# *HIKVISION EUROPE*

## Monthly External Technical Newsletter

Oct 2020

### DS-2CD21X3G0-IU Series IP Camera

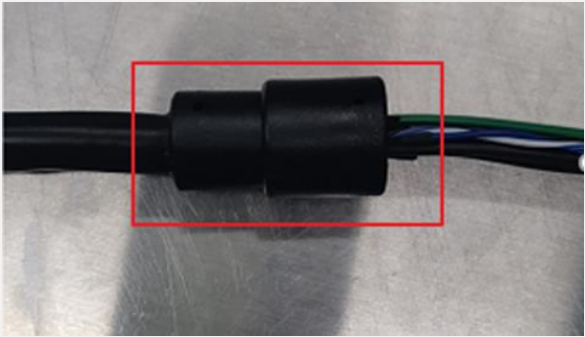
Improve the installation method of dome 46's dessicant .

Change Before	Change After
 <p data-bbox="111 1002 682 1073">The desiccant is tied to the U-shaped bracket with a tie.</p>	 <p data-bbox="732 1002 1303 1073">The desiccant is pasted on the side wall of the upper cover.</p>

DS-2CD4BX6FWD-IZ Series IP Camera

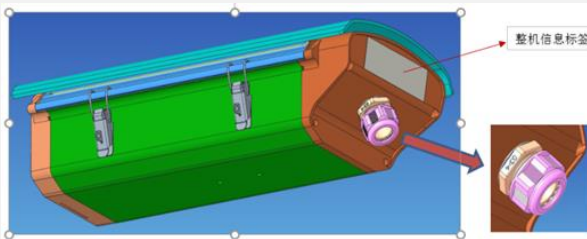
Update the front cover.

Update the front cover.

DS-2CD4026FWD, DS-2CD502XG0E Series IP Camera  
and DS-1331HZ Series Accessory

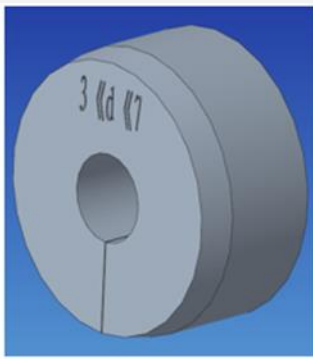
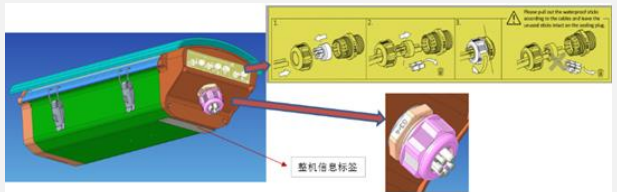
Remove the photosensitive sensor, and replace by software

Original: Waterproof plug without mounting paper.  
Label is on the back end of camera body.

New: Waterproof plug(New type) with mounting paper.  
Label is under the camera body.
